DPD PROJECT No: 3013130
1099 STEWART STREET + 1050 HOWELL STREET

Design Review Board Recommendation Meeting
4 DECEMBER 2012

H. THE SKYLINE AND ROOF

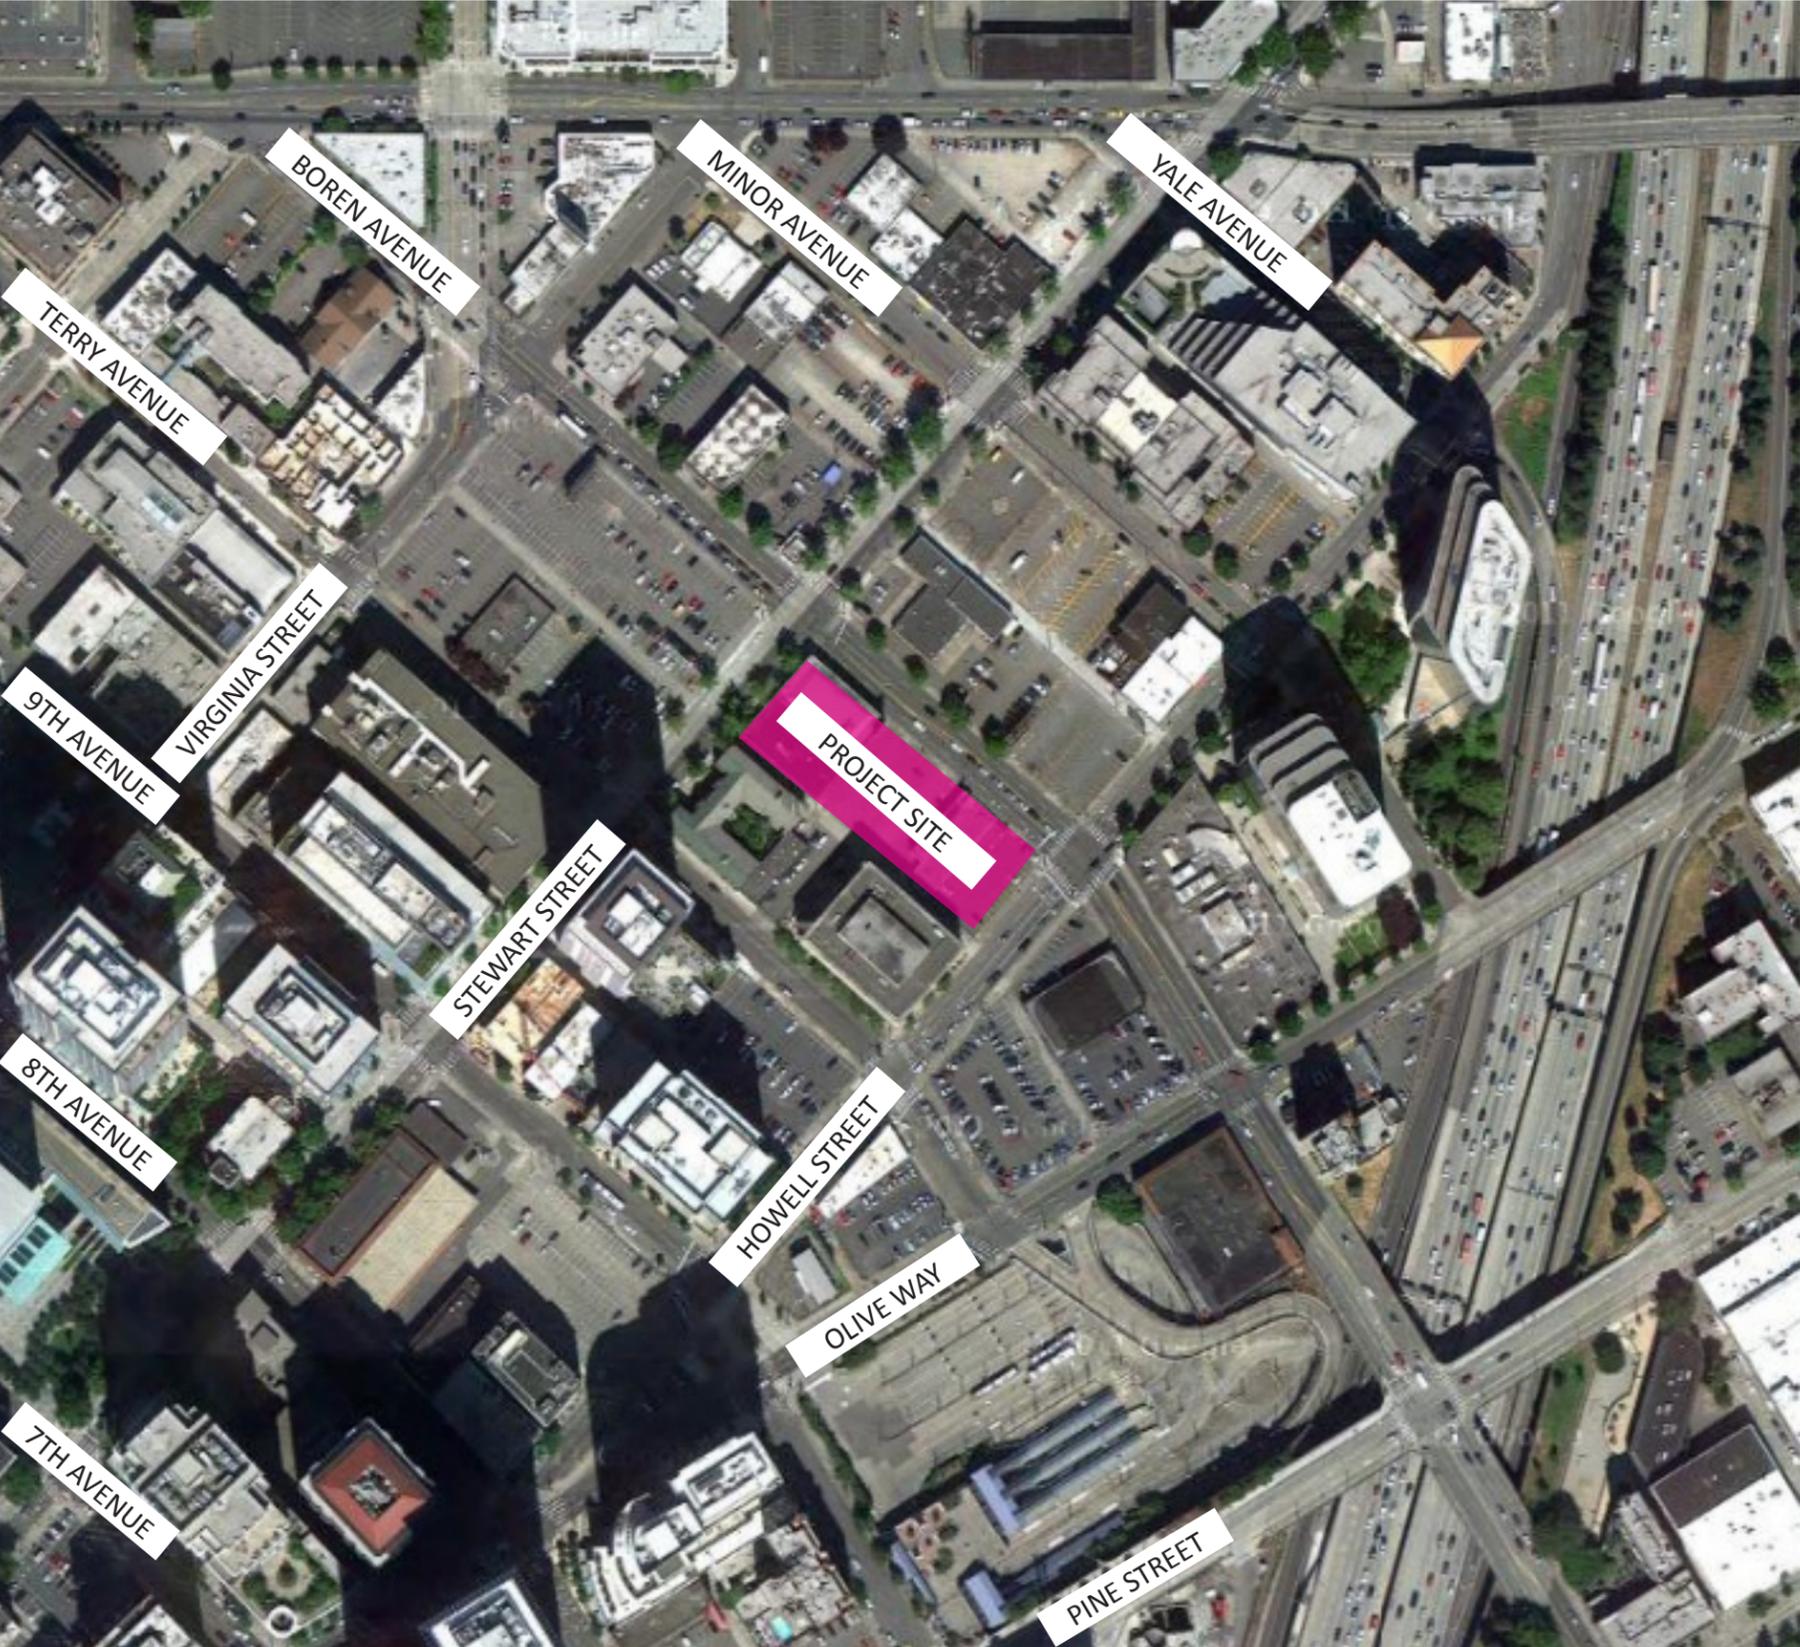
EDG items E, H; MUP comment #4

The board noted that the proposal should endeavor to have vertical difference between the buildings. Per zoning, the buildings must stay under 160' in height or be subject to tower separation which would make the project unfeasible. Therefore, when grade change, optimal floor to floor height for the program type, FAR, and zoning are taken into account, the vertical height of the buildings is 18 inches. This is not enough difference to create a stepped roofline that is proportional and elegant. The buildings do provide a well defined edge at the roofline which is a distinctive top to the building. The roof surface is a high albedo to minimize heat island and the mechanical areas are screened from view by perforated metal screens.

05. STREETScape - THE PORTE-COCHERE / PEDESTRIAN SAFETY

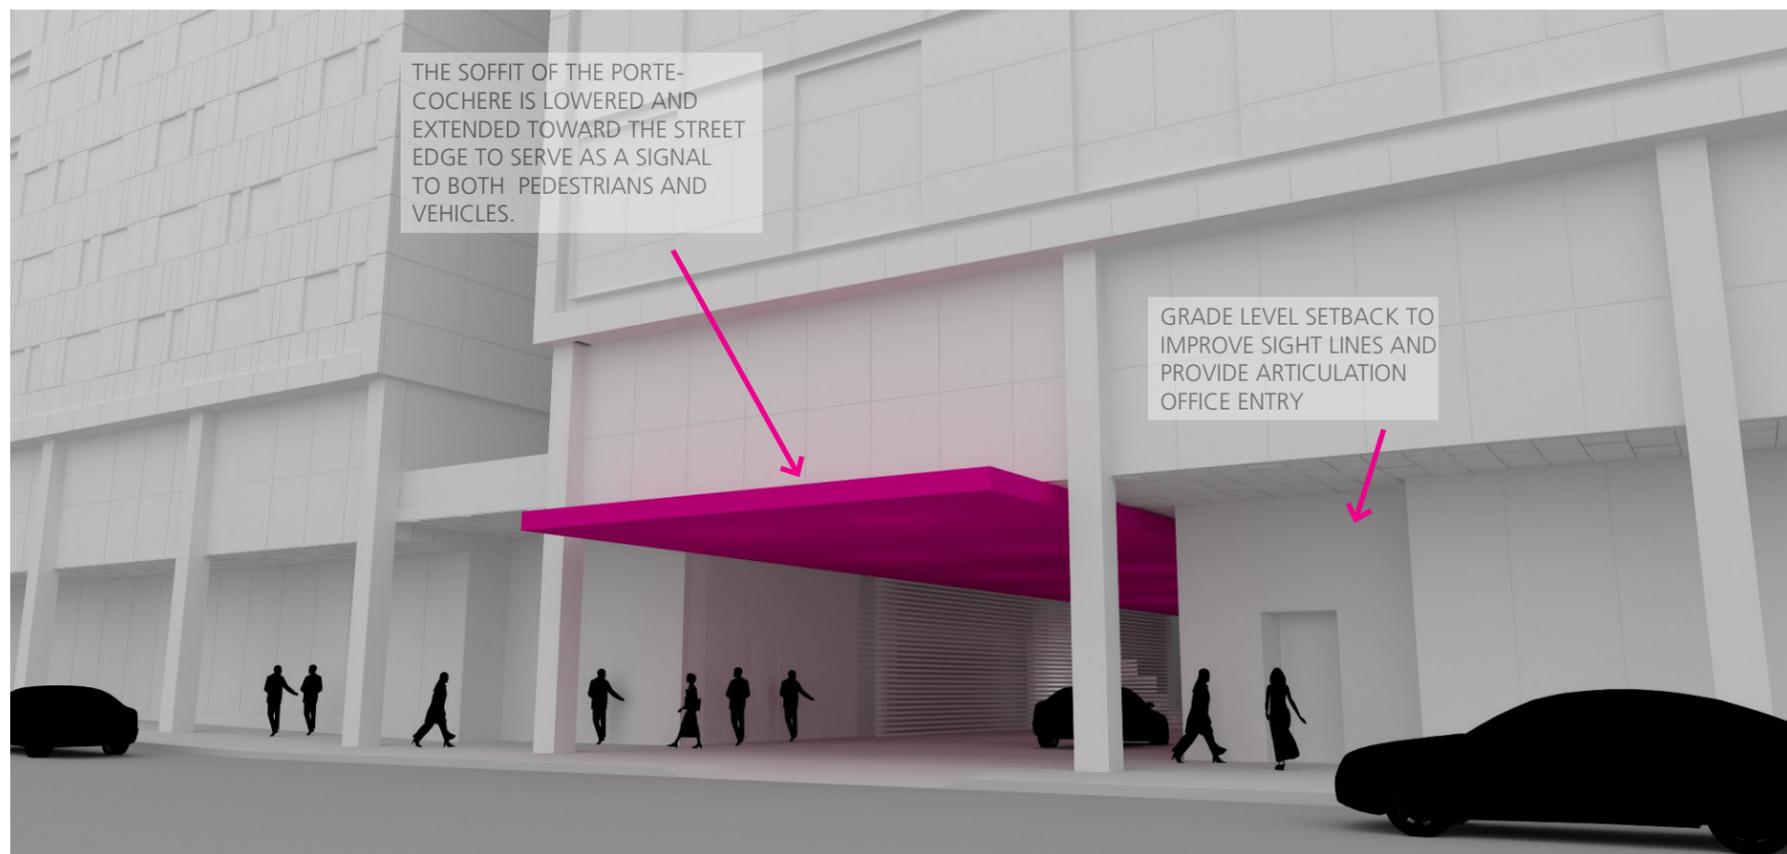
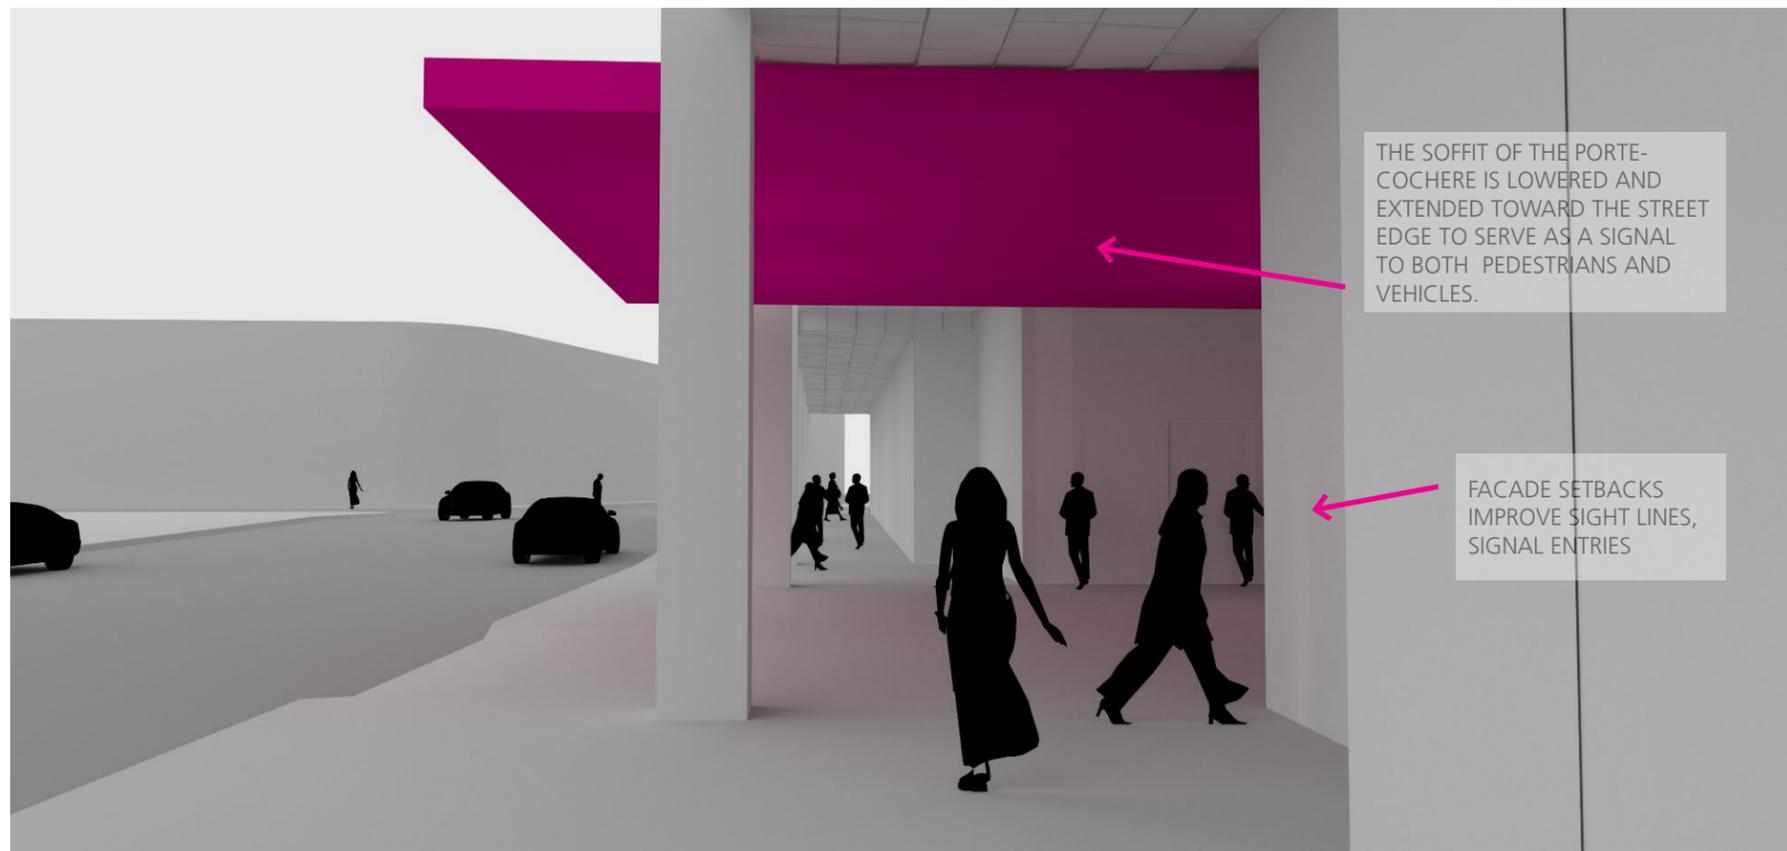
Comment: Please also provide a response to EDG direction for Guidelines C-1 and E-1, demonstrating how the proposed Porte-Cochère and curb cut design will maximize safety for pedestrians, create a design transition between the office and hotel portions of the development, and how the colonnade will relate to this design.

See response to comment above. In addition, the entrance on Boren Avenue along with the porte-cochere would provide street-front features and landscaping to provide an engaging pedestrian experience. The number of curb cuts on Boren Avenue is being reduced from three to one, with the remaining curb cut located nearly mid-way between the two adjacent intersections as desired per the Guidelines. A different type of pattern or paving surface will be used at the site driveway across the sidewalk to notify pedestrians that vehicles could be using this area.

06. DEPARTURE 1 - FACADE MODULATION

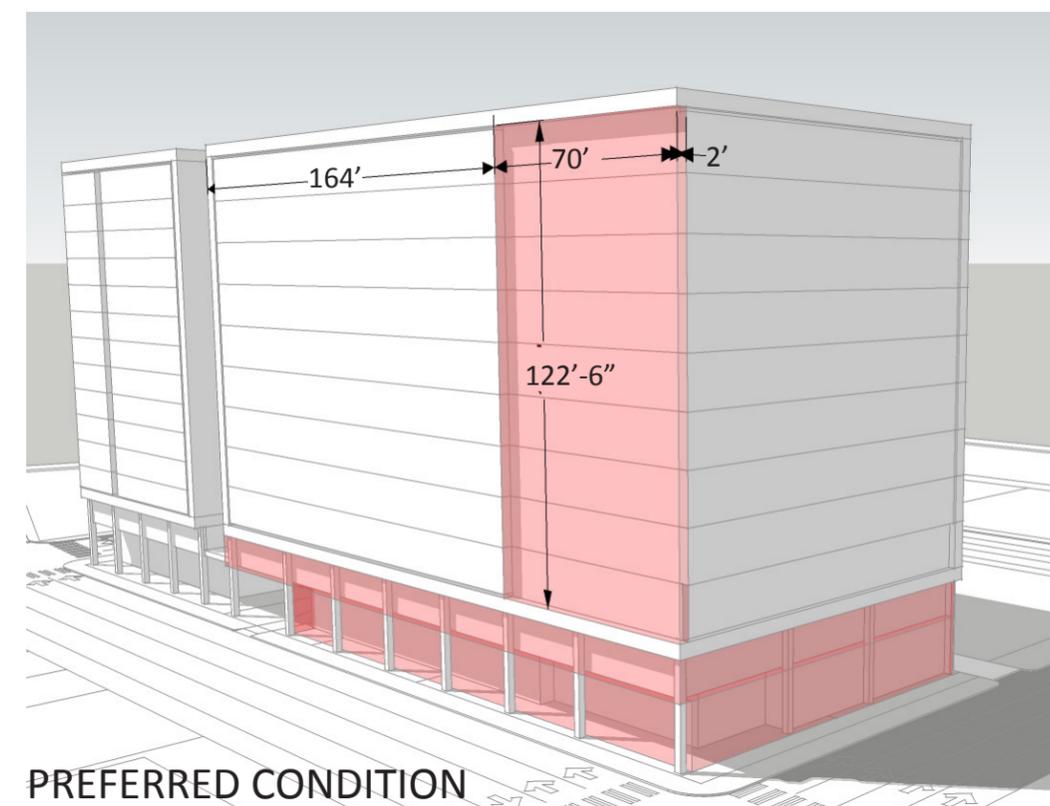
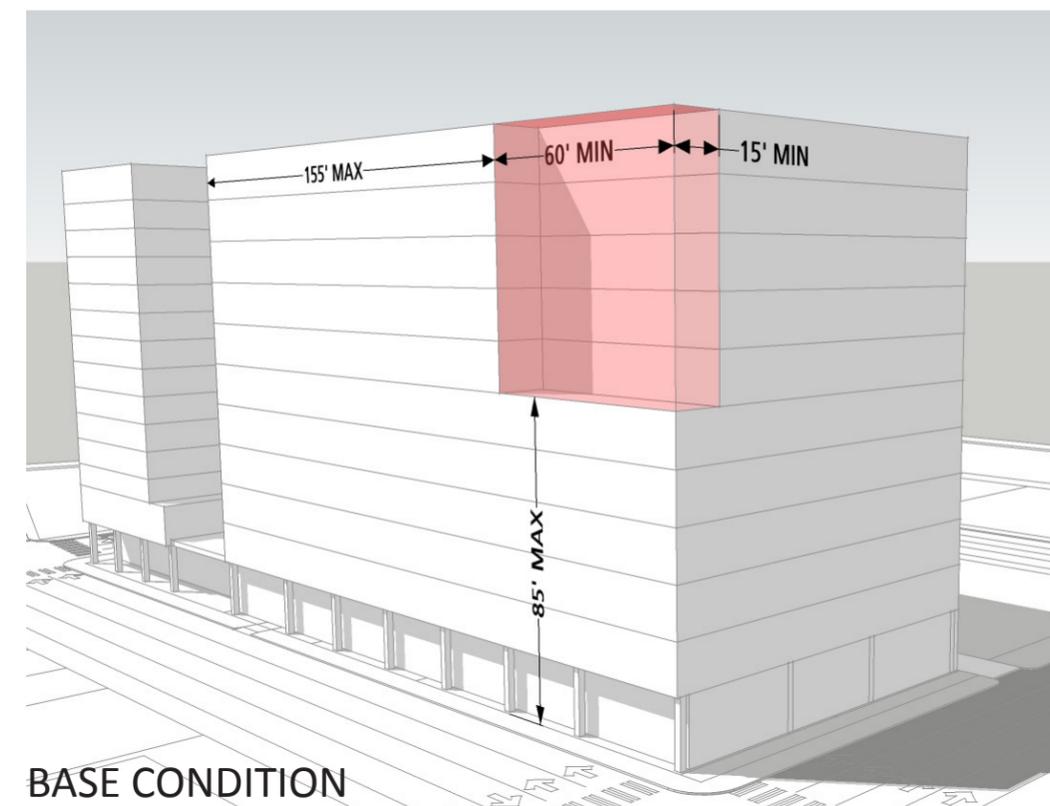
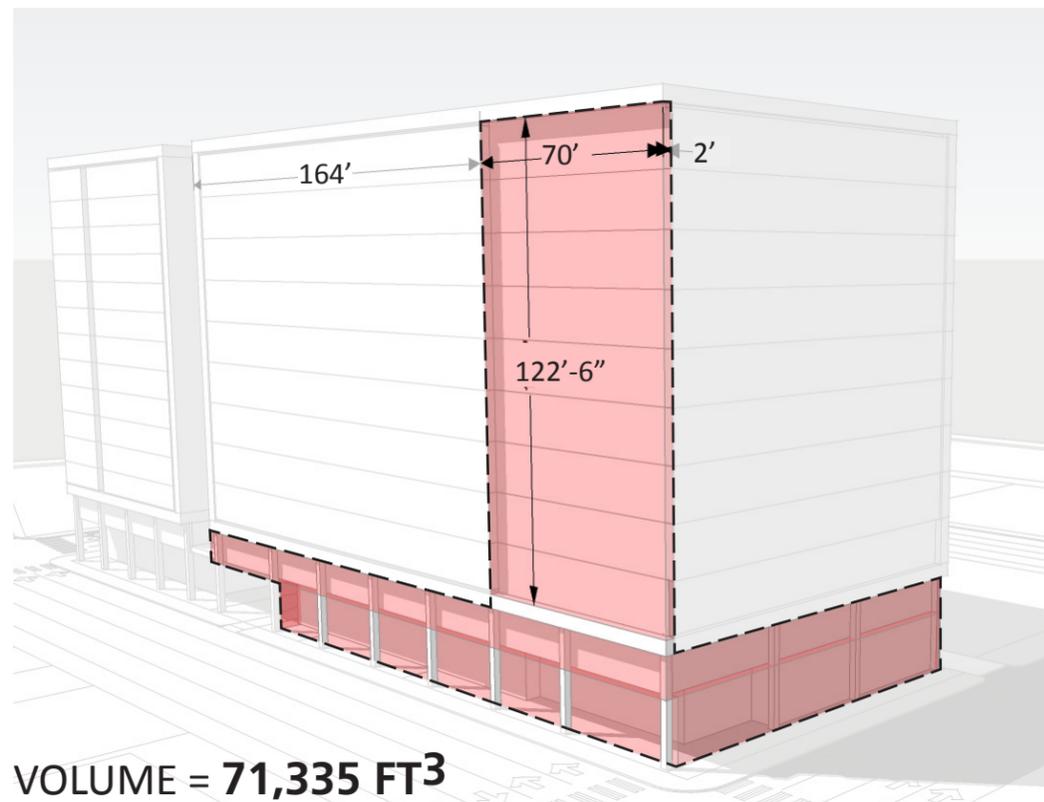
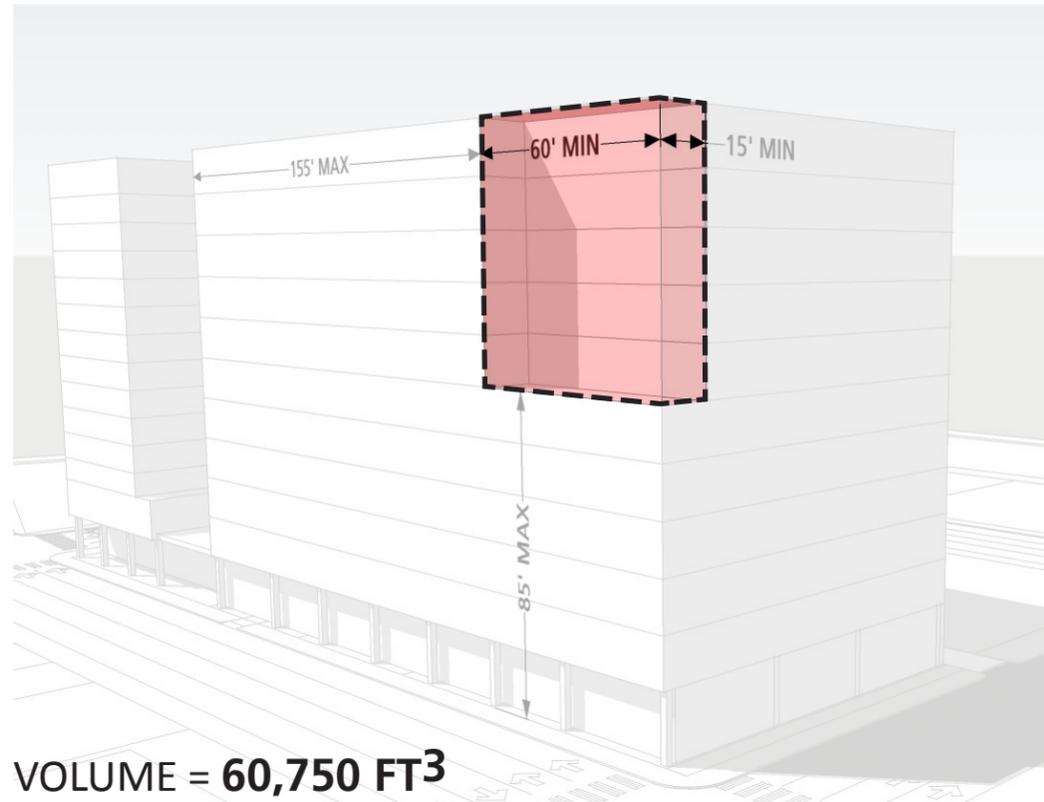
1. Facade modulation is required above a height of eighty-five (85) feet above the sidewalk for any portion of a structure located within fifteen (15) feet of a street property line.

Table 23.49.058A - Maximum length of un-modulated facade within 15' of street property line for structures 86 to 160 feet is 155 feet.

3. Any portion of a facade exceeding the maximum length of facade prescribed on Table 23.49.058A shall be set back a minimum of fifteen (15) feet from the street property line for a minimum distance of sixty (60) feet before any other portion may be within fifteen (15) feet of the street property line.

Maximum length of un-modulated facade is 164' on Boren St, Setback is 2'

Facade modulation has been provided the at the upper level beginning at 34'. Additional upper level setback will adversely effect future planning of the technology office use AND decrease the separation between the two buildings. Additionally, the grade level facades have been held back at the Boren Avenue property line by 8-16' for increased public benefit and relief from heavy Boren Avenue traffic.
